Re: **TRI-COUNTY COUNCIL/CAREER CENTER SITE IMPROVEMENTS PROJECT**
Salisbury, Maryland
2009145.00

ADDENDUM FIVE

SKETCH #	SKE-2
PROJECT:	TCC
PROJECT #:	1031029
DATE:	08/17/11 - ADDENDUM 5
DRAWING:	E300
REVISION#	5

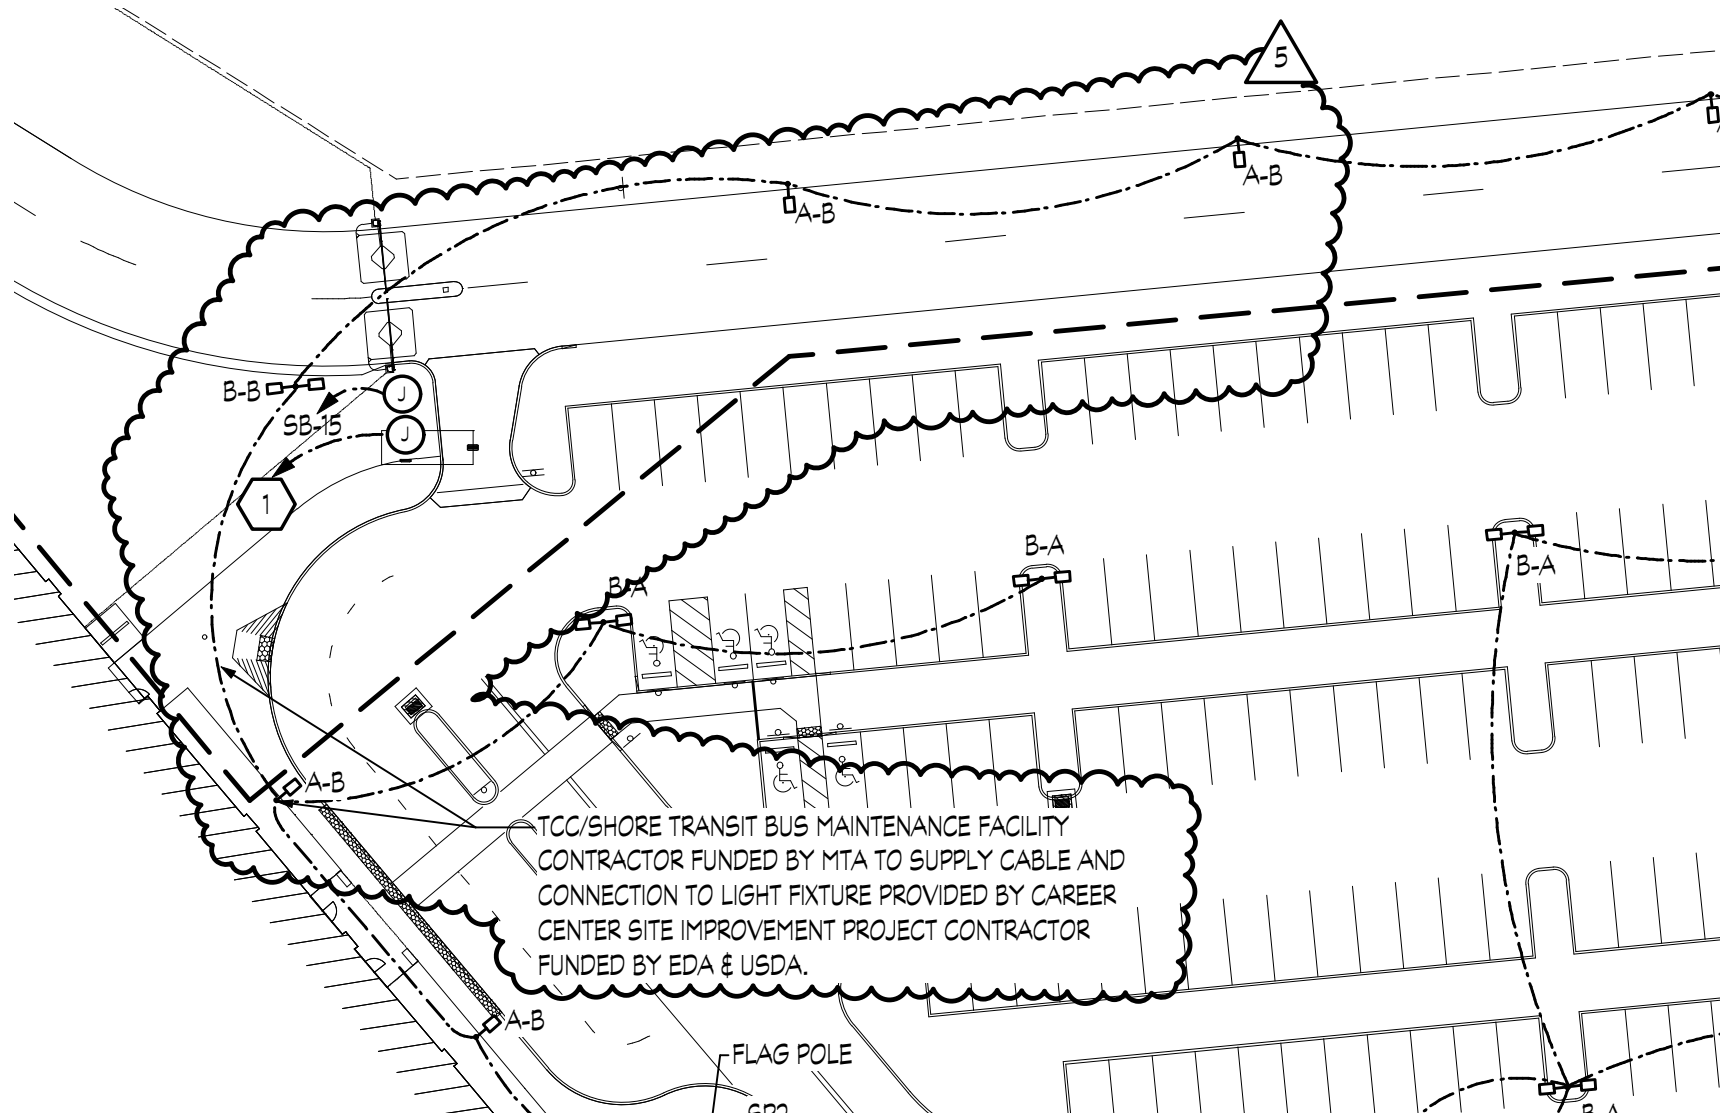
5. Please clarify the scope of work related to note #1 on Drawing E300. Are we to provide and install (1) 1" conduit from a weatherproof junction box to the maintenance building or to the scope of work line?

6. Please clarify the scope of work related to the power circuit SB-15 shown near the Fare Drop location.
Answer: Circuit SB-15 is for power to the motorized gate that will now be included in the TCC Maintenance Building project per changes made in sketch SKE-2.

Answer: See sketch SKE-2 dated 08/17/11 issued via this addendum.. Phasing line has been relocated to include the installation of motorized gate and security camera in the TCC Maintenance Building project. These conduits and boxes will not be installed under this project contract.
